FIG. 4D

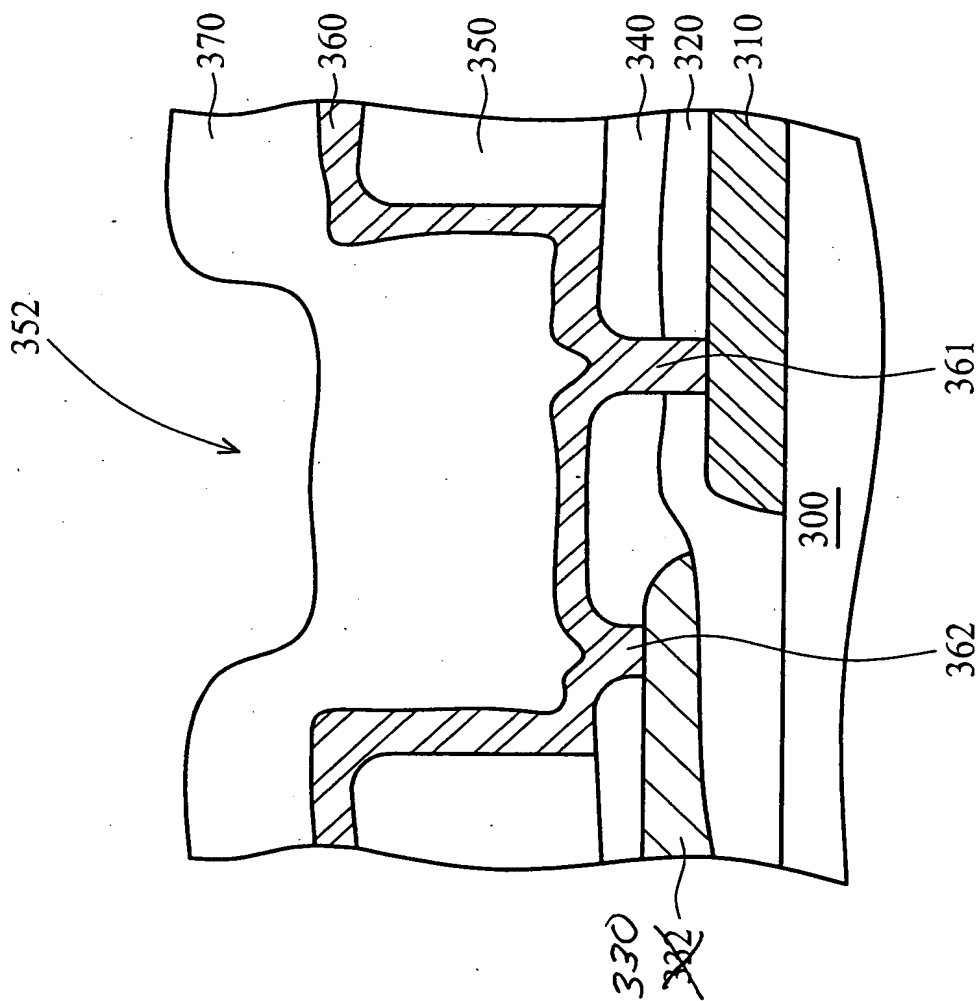
In FIG. 4D, “ 332” is changed to “ 330,” as shown in the accompanying annotated drawing sheet.
